THE MARYLAND-NATIONAL CAPITAL PARK AND PLANNING COMMISSION

MEMORANDUM

REVIEW TYPE: **Site Plan Review**
CASE #: **8-04008A**
PROJECT NAME: Potomac Ridge Behavioral Health
APPLYING FOR: 814 square feet of classroom addition
REVIEW BASIS: Div. 59-D-3 of Montgomery County Zoning Ordinance

Overall Site Plan #8-04008A

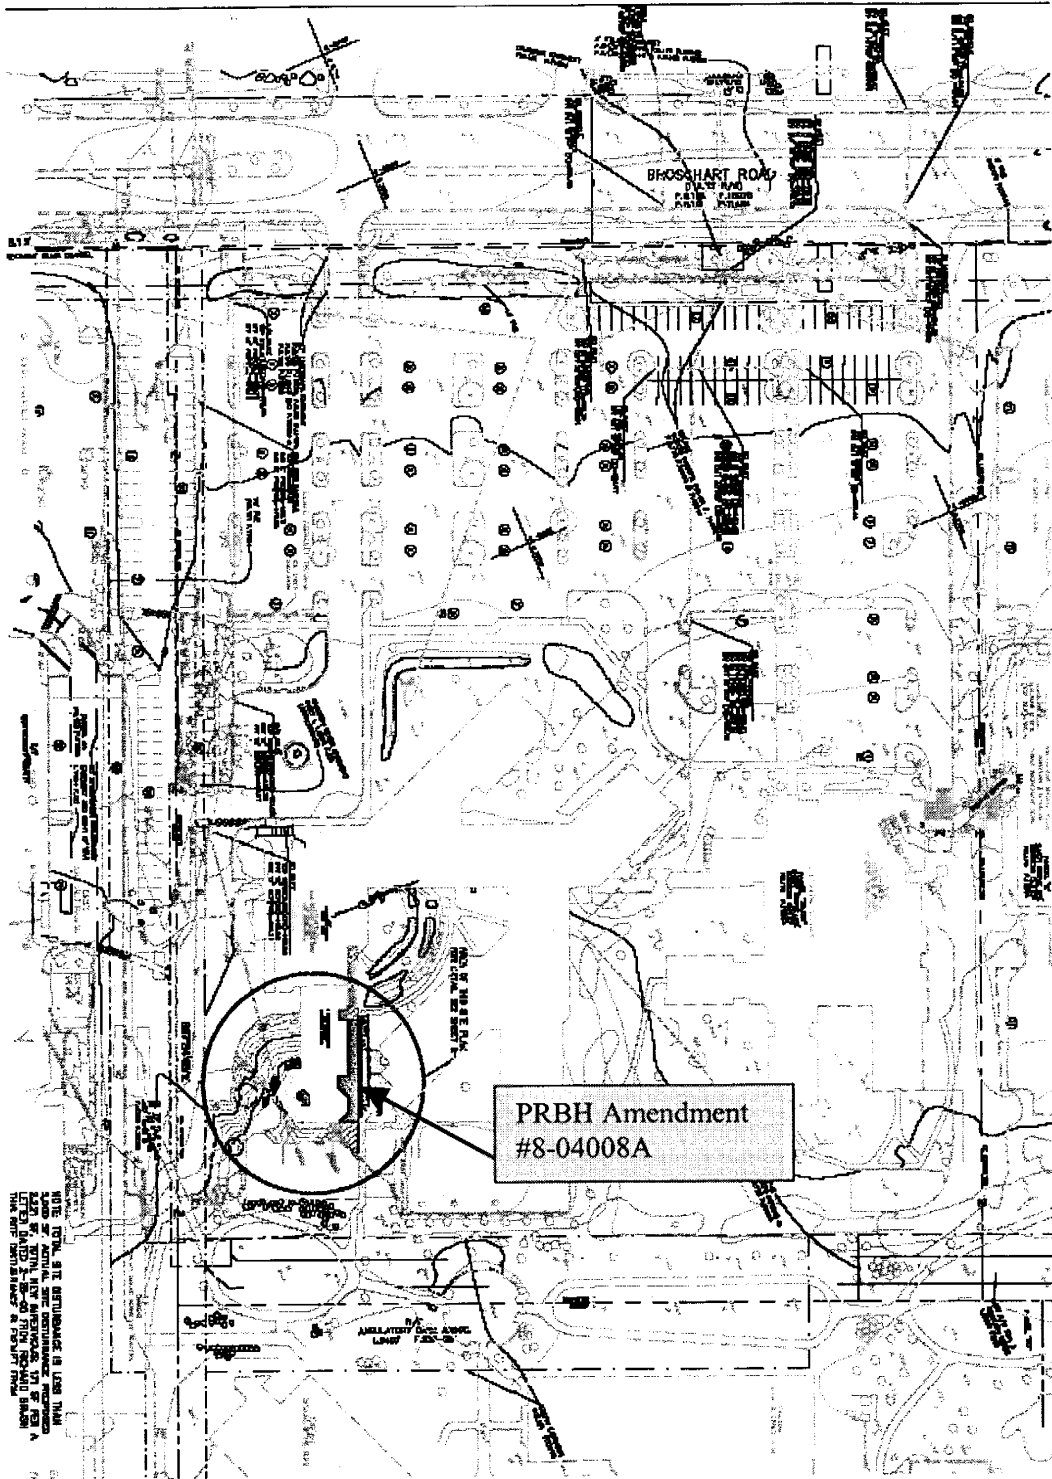
The proposal is for an 814 square foot addition to an existing wing, creating larger space for a behavioral health facility. The site plan also includes the creation of a secure outdoor play area bounded by an 8-foot board on board fence. The outdoor play area includes rubber mulch; play equipment will be added per the facility needs.

Detailed View Site Plan #8-04008A

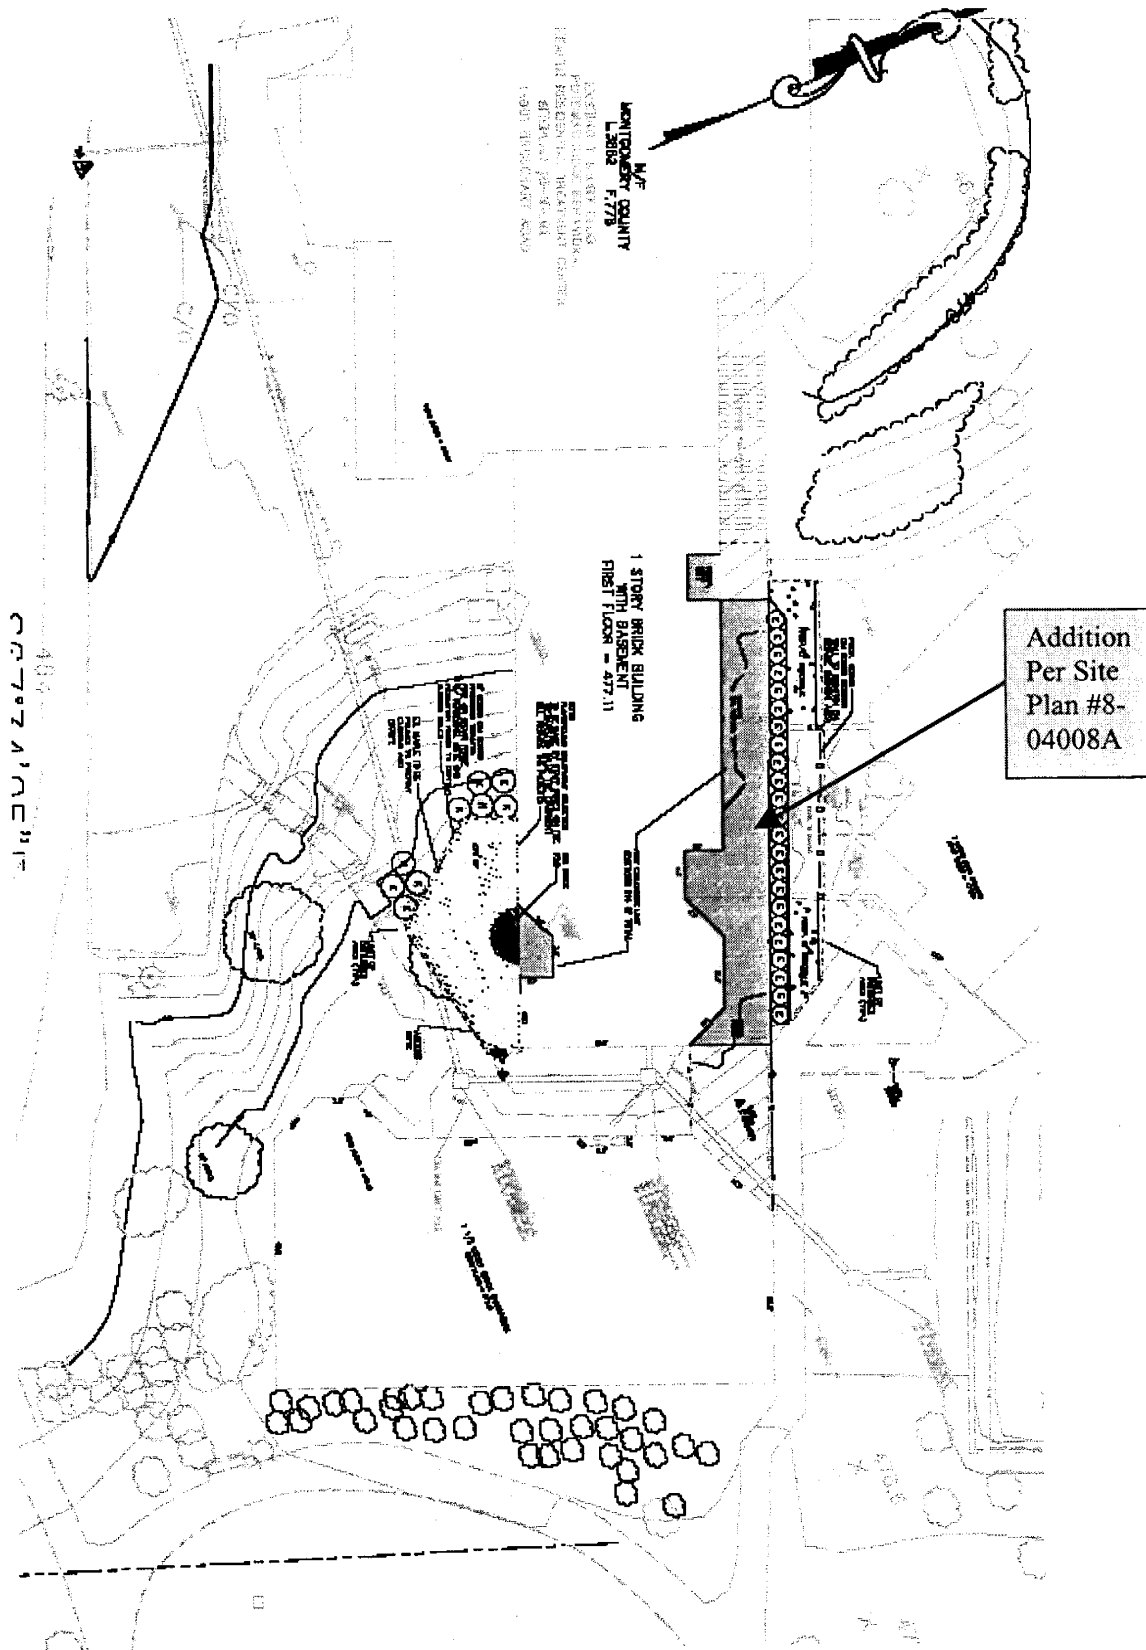
Applicant shall provide 4 bike racks on site for use of employees. The landscape plan shall include a more open variety of evergreen shrub (*Viburnum Pragensense*) adjacent to the northern façade of the wing.

The proposed landscaping on the site consists of preservation of an existing shade tree and introduction of shrubbery adjacent to the building to provide internal privacy for the patients.
